Product Change Notice (PCN)

PCN Number: PCN-0374346R-01

Product(s) Affected: *CST-931AP*

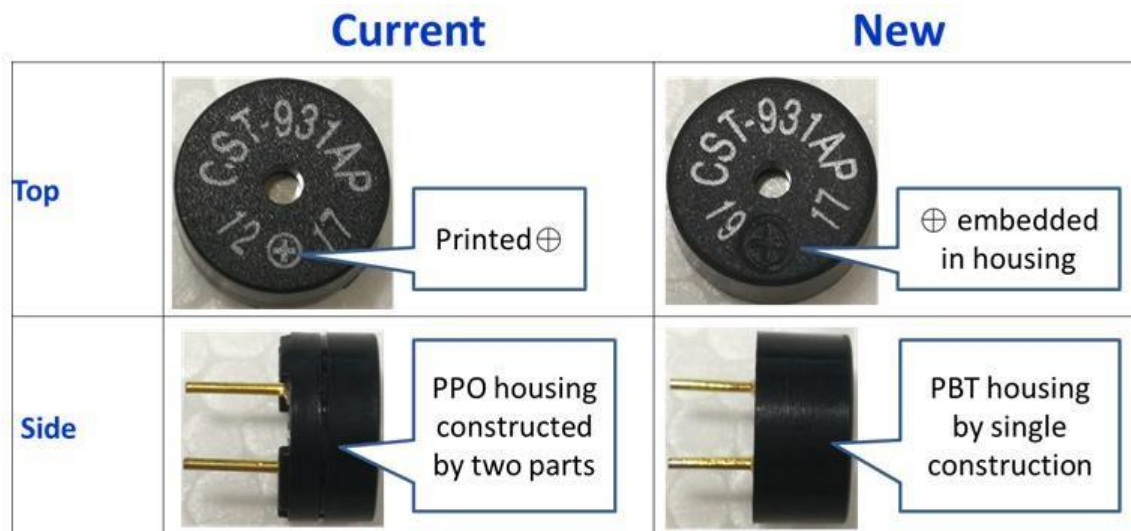
Description of Change: *Housing changing from two pieces (top+bottom) to one single plastic piece, plastic changing to higher temperature PBT material, positive terminal marking embedded into housing instead of printed.*
